END OF ADDENDUM NUMBER ONE (1)

CIVIL PLANS	
CCD PROJECT	23043.10
DATE ISSUED	August 6, 2024
DATE REVISED	August 15, 2024
#	1

CLINTON PARKS - PHASE I
 CITY OF CLINTON
 TRACEWAY PARKS & KIDS TOWNE PARK

PLUMBING PLANS
CCD PROJECT 23043.10
DATE ISSUED AUGUST 6, 2024
DATE REVISED 8/15/24
DRAWING NO. P100 R1

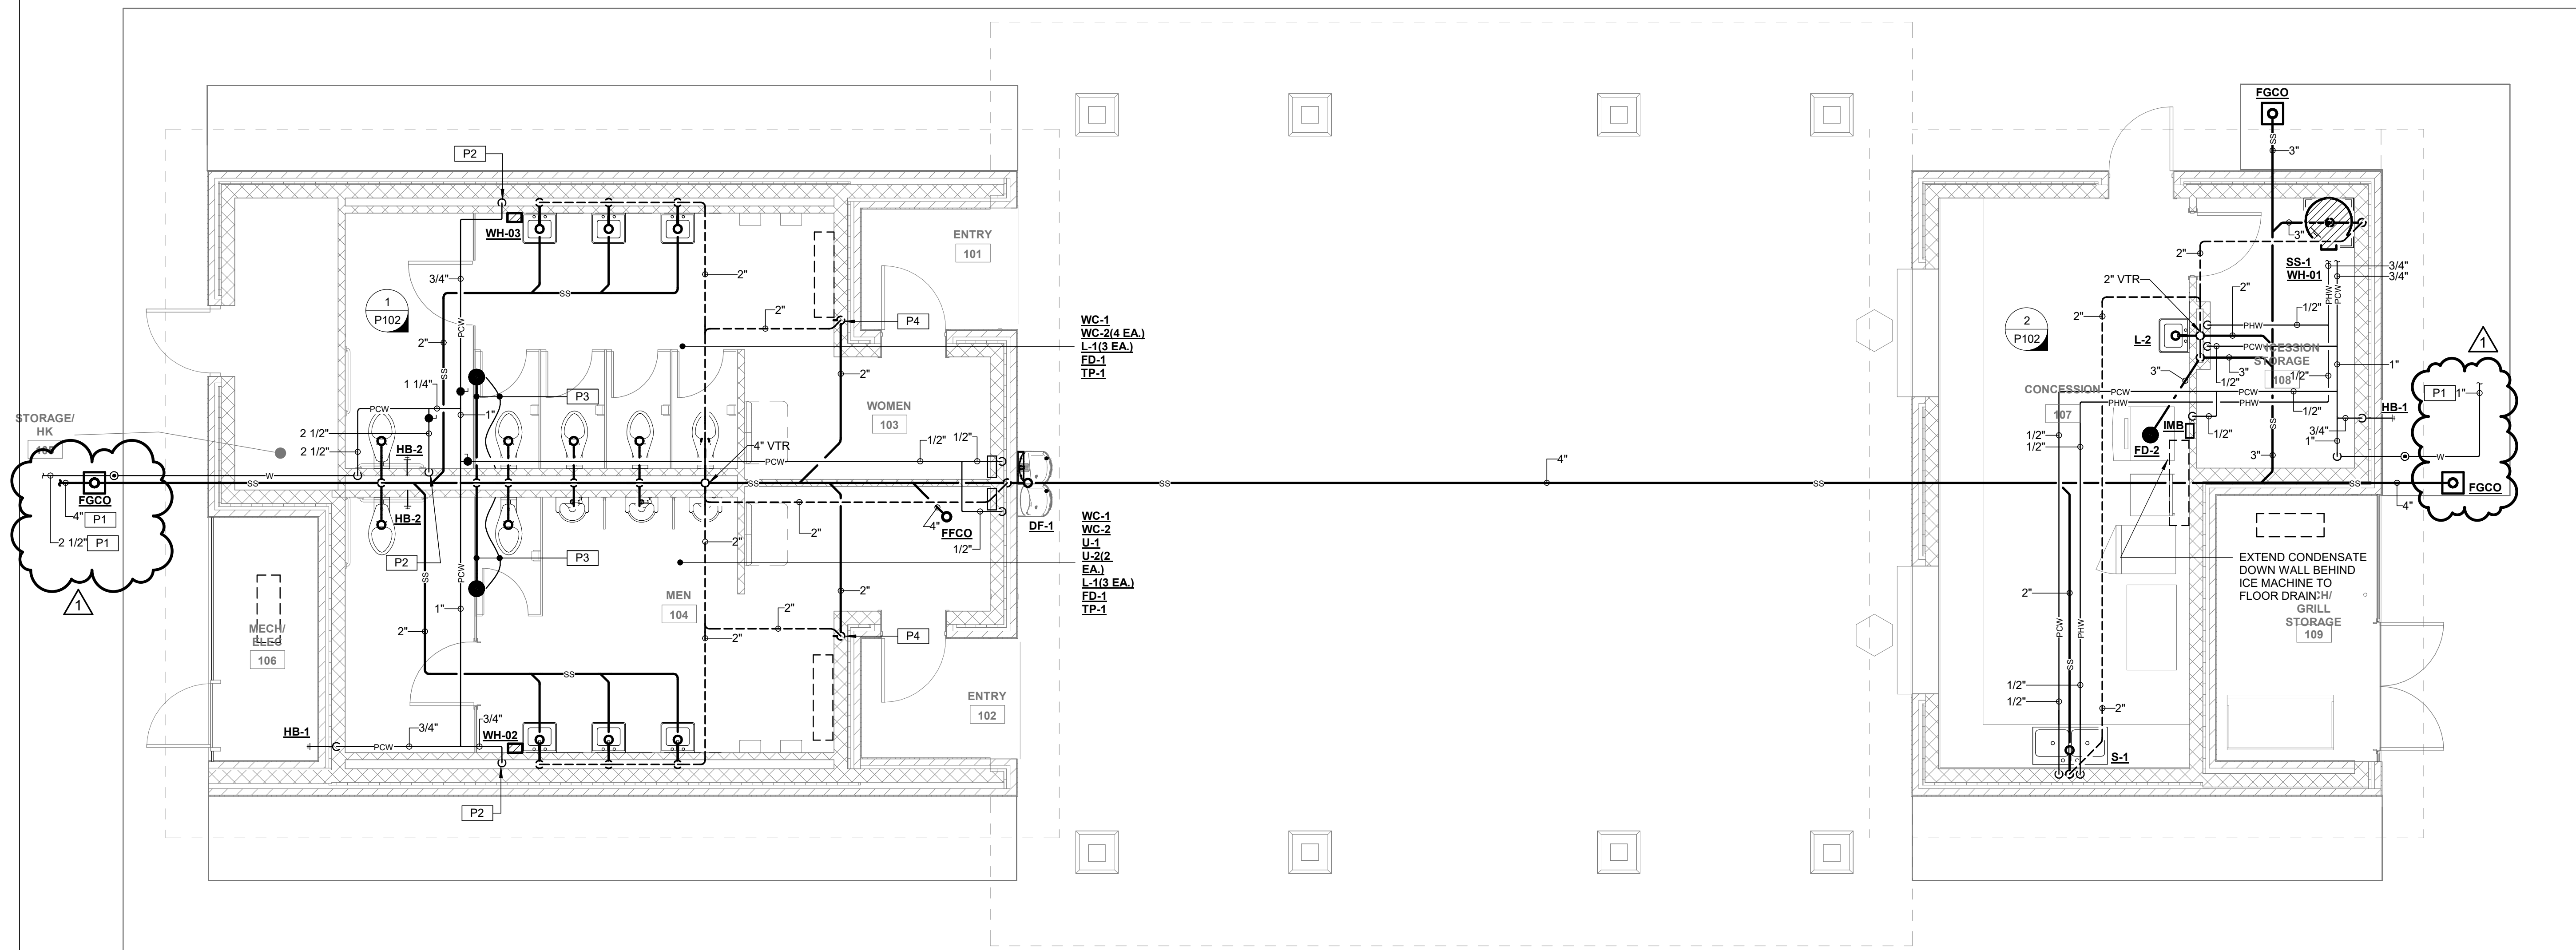
14. **DRAWING A311, DETAILS** – On Detail 11, change “planks” to be “slats”.
15. **DRAWING P100, PLUMBING PLANS** – Replace with attached P100 R1 dated as revised August 15, 2024.

DRAWING NO.
**P101
 R1**

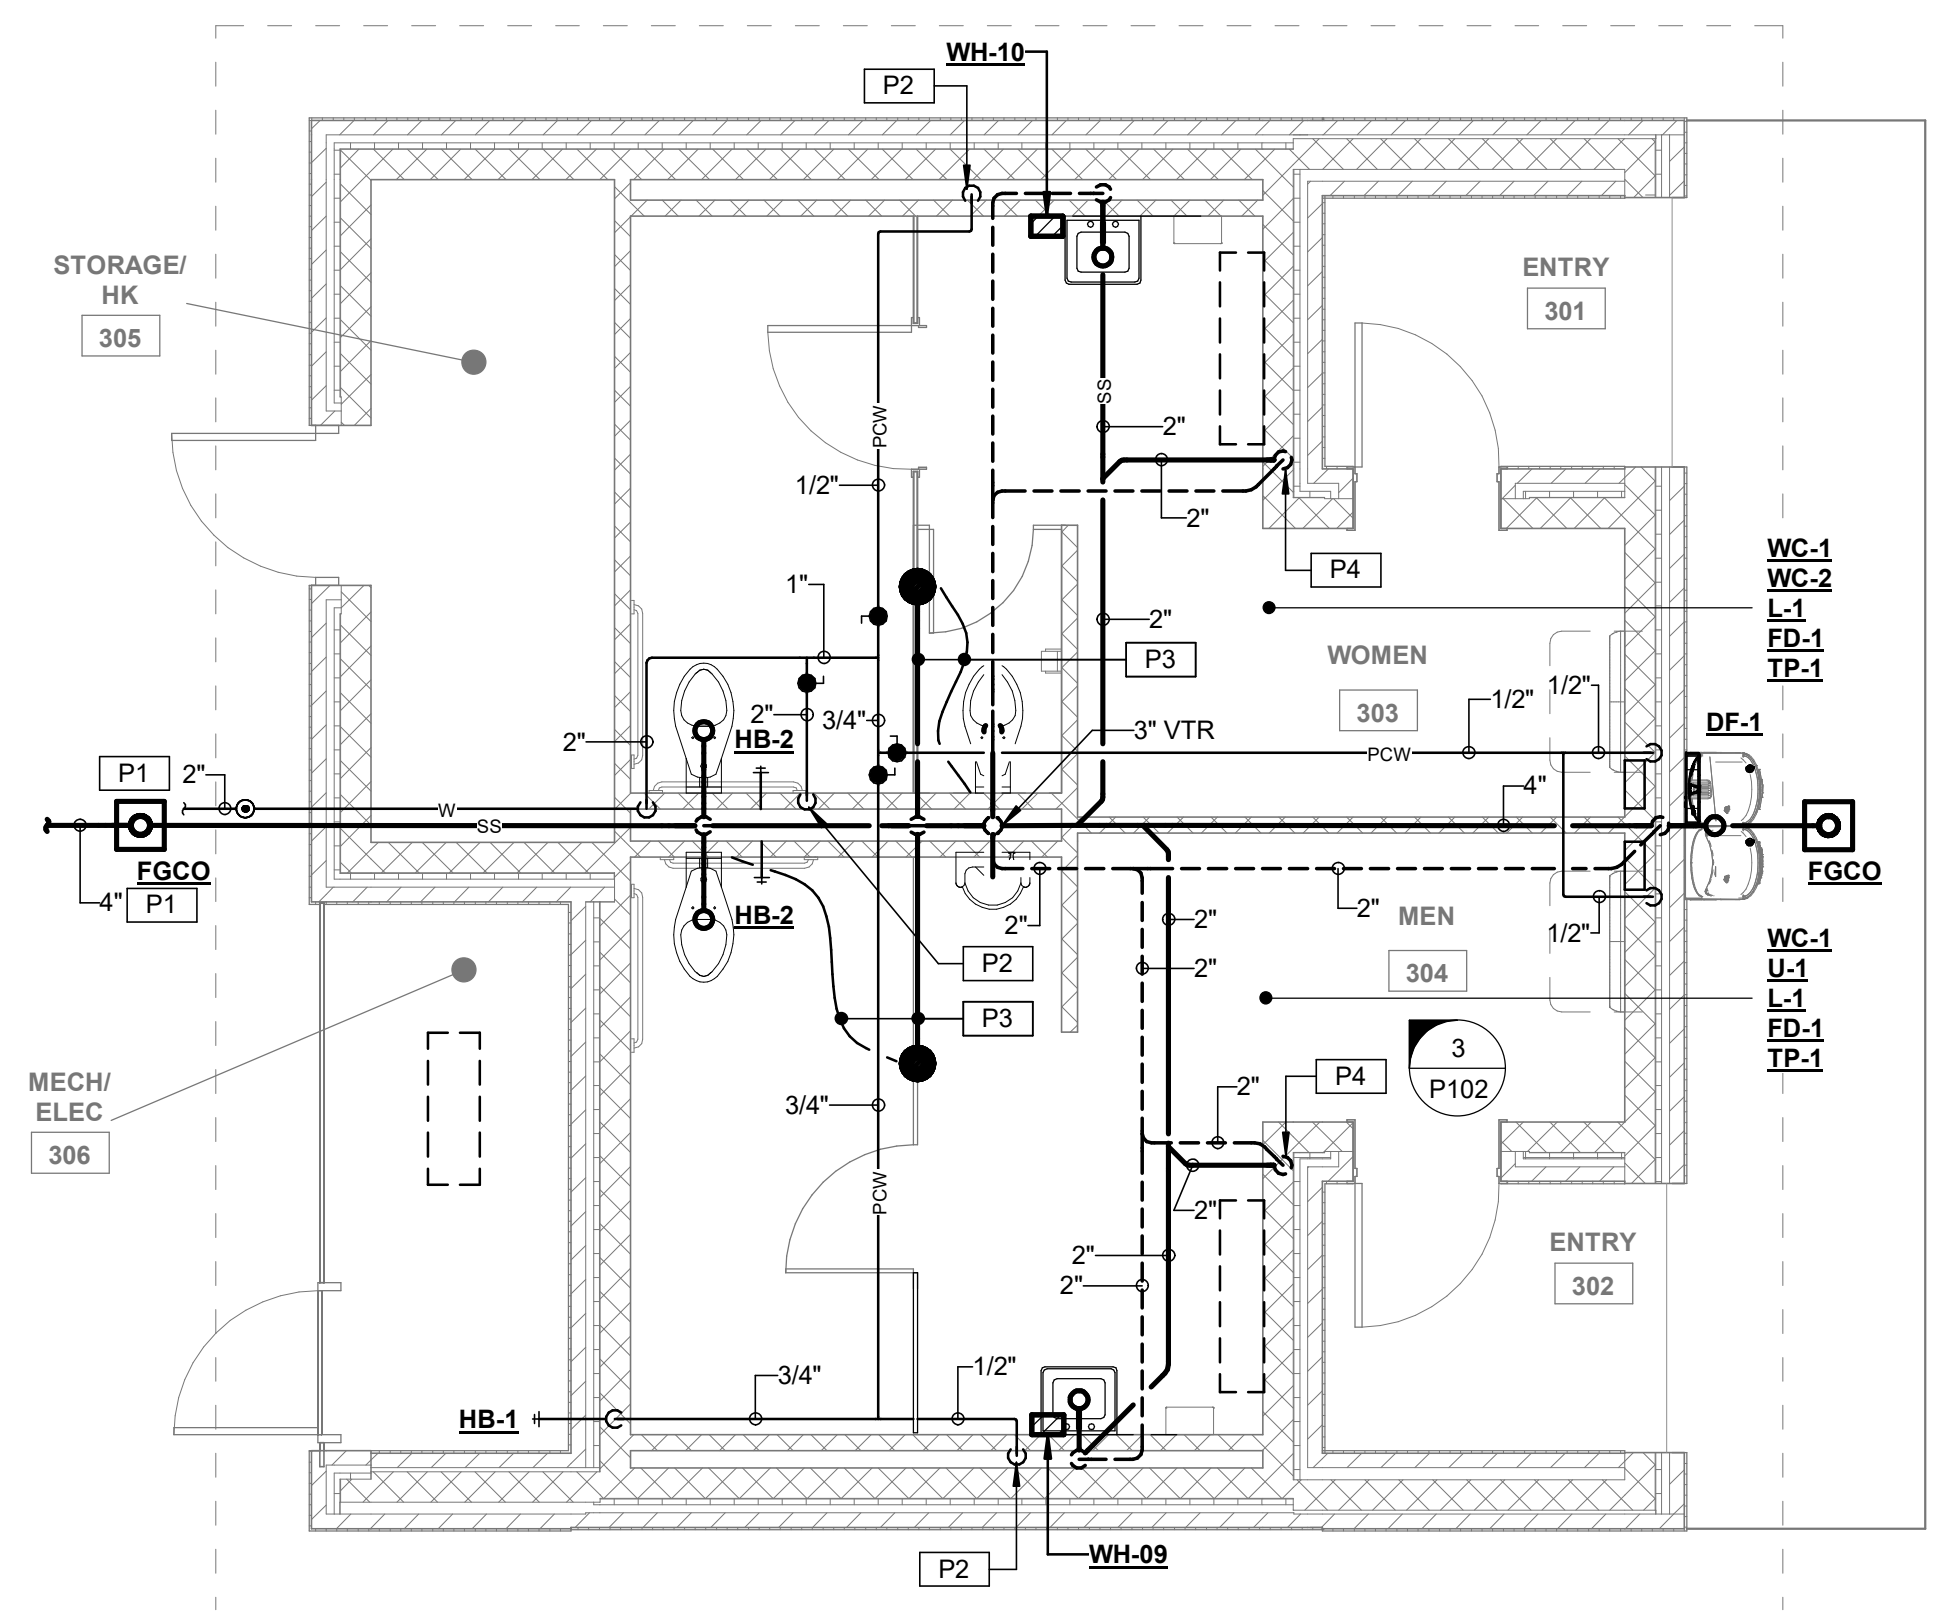
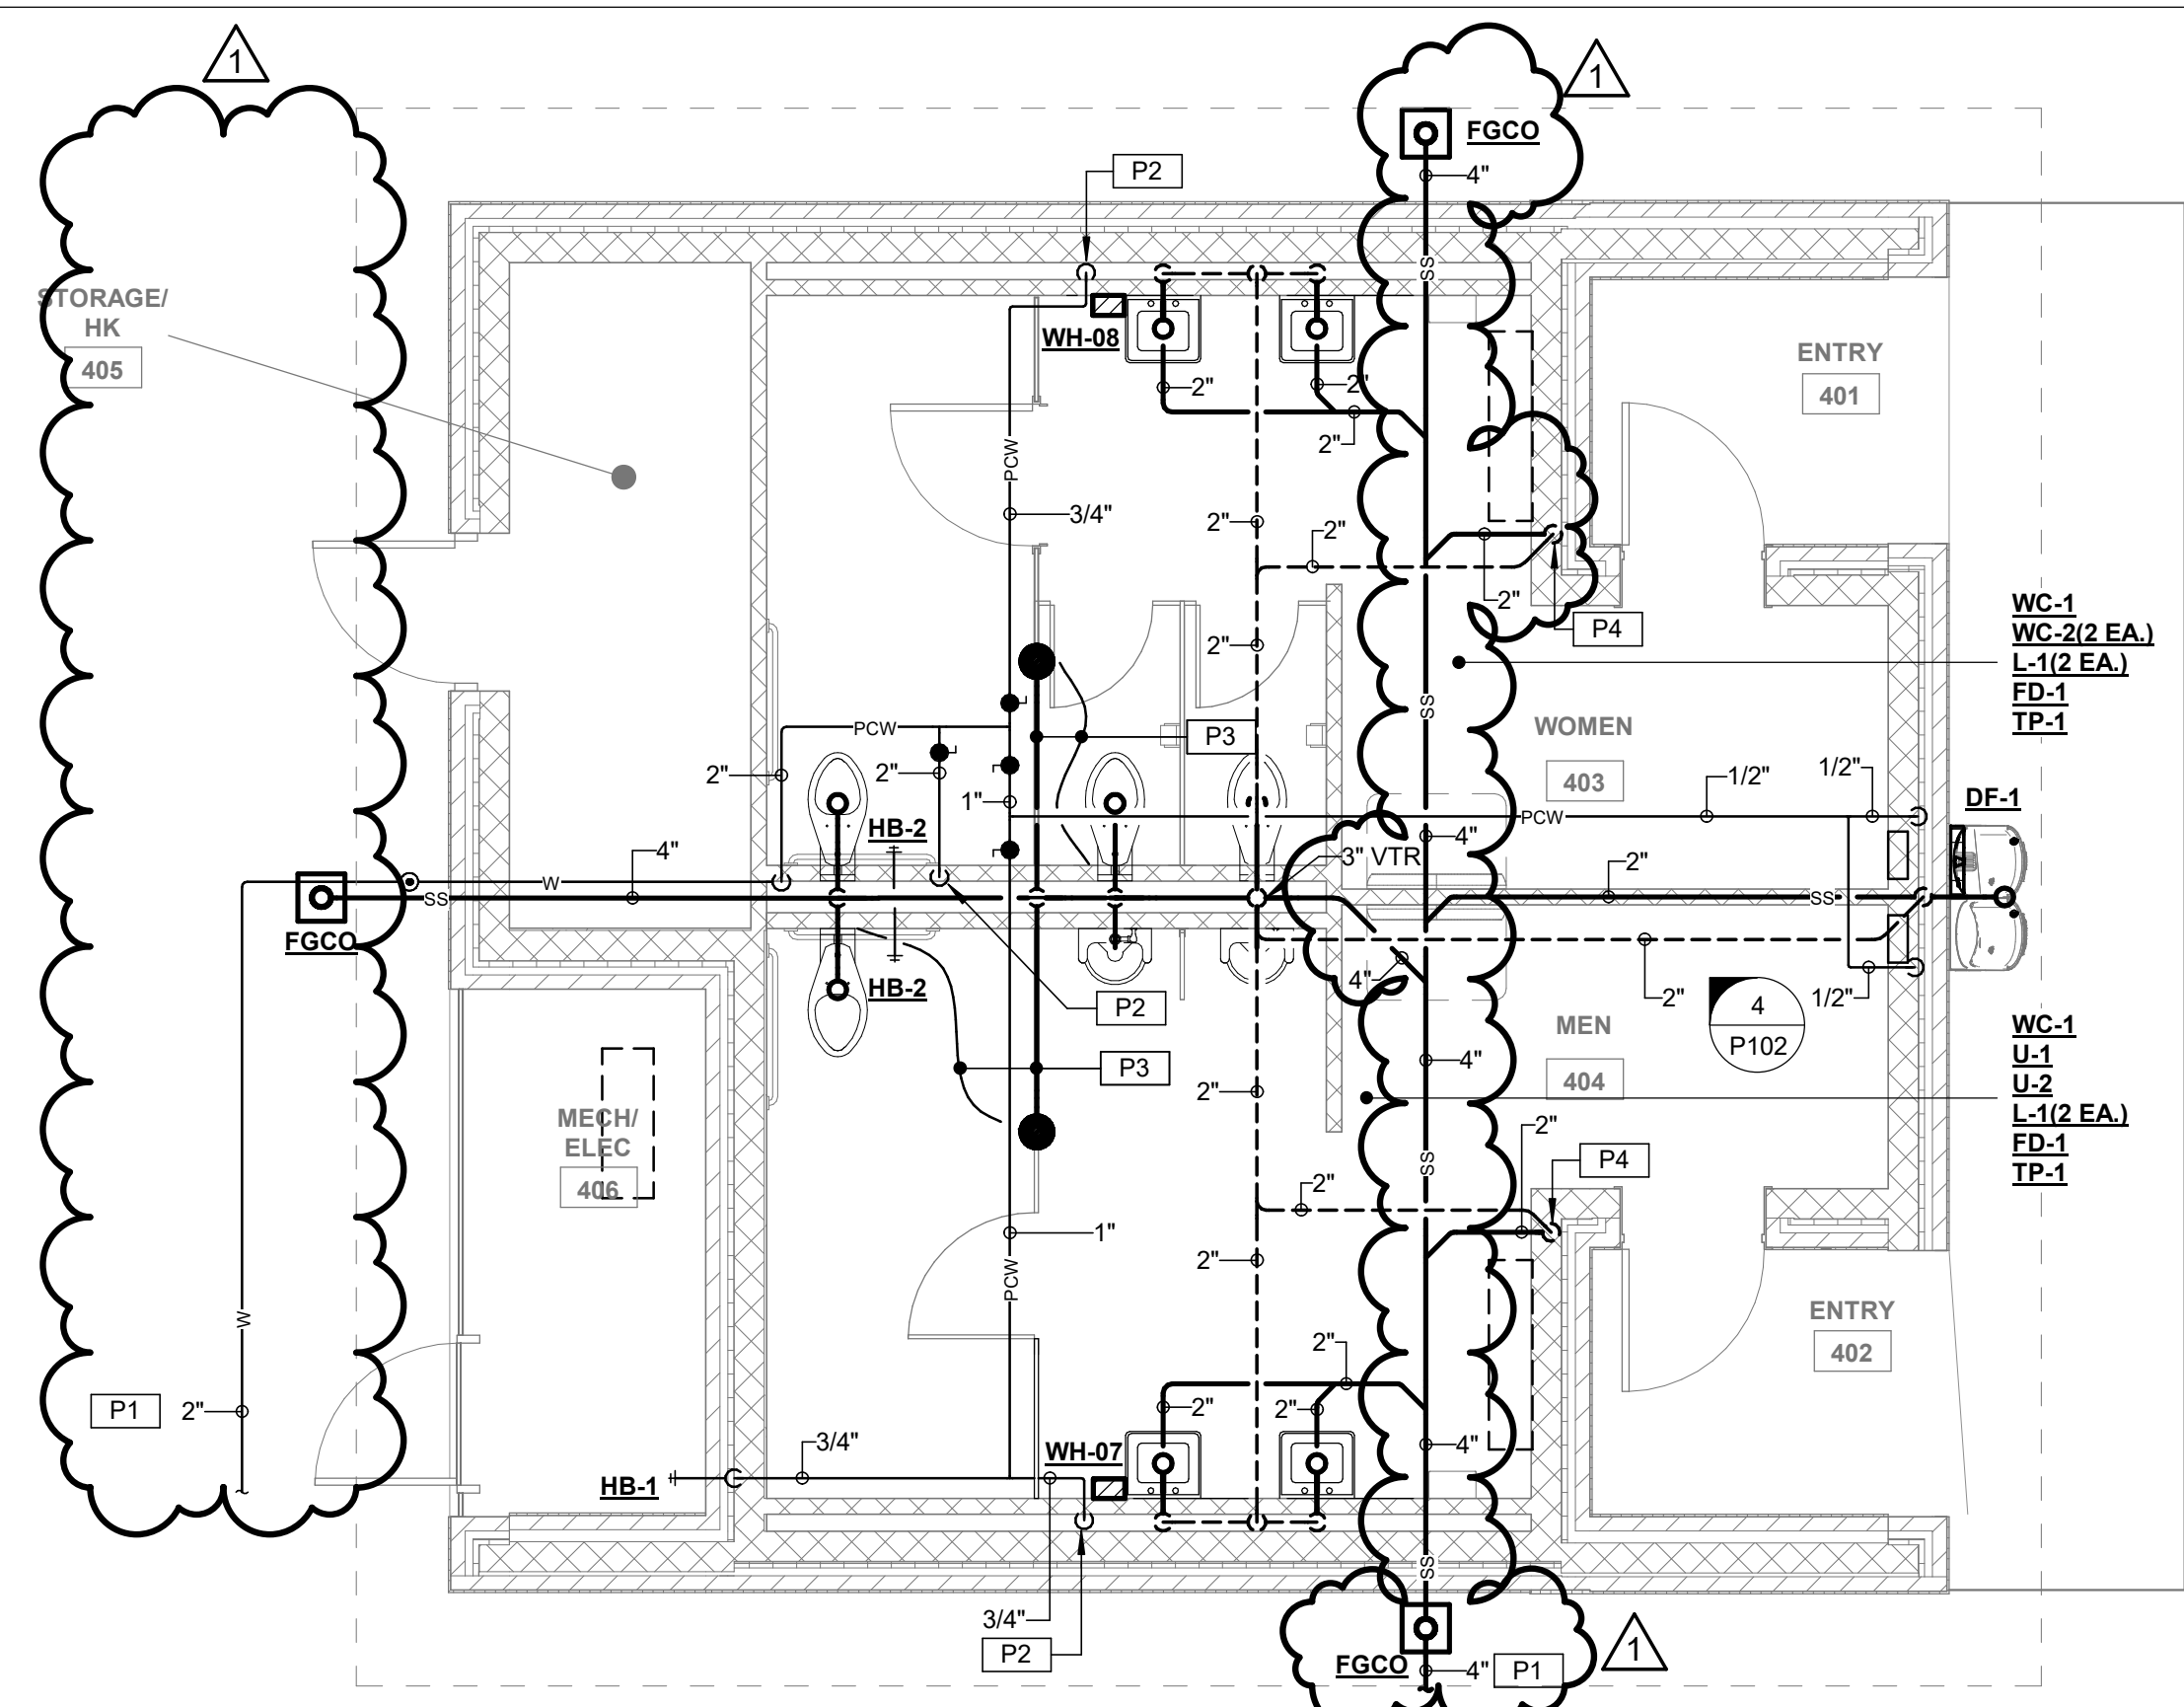
16. **DRAWING P101, PLUMBING PLANS** – Replace with attached P101 R1 dated as revised August 15, 2024.
17. **DRAWING P102, PLUMBING RISERS** – Replace with attached P102 R1 dated as revised August 15, 2024.
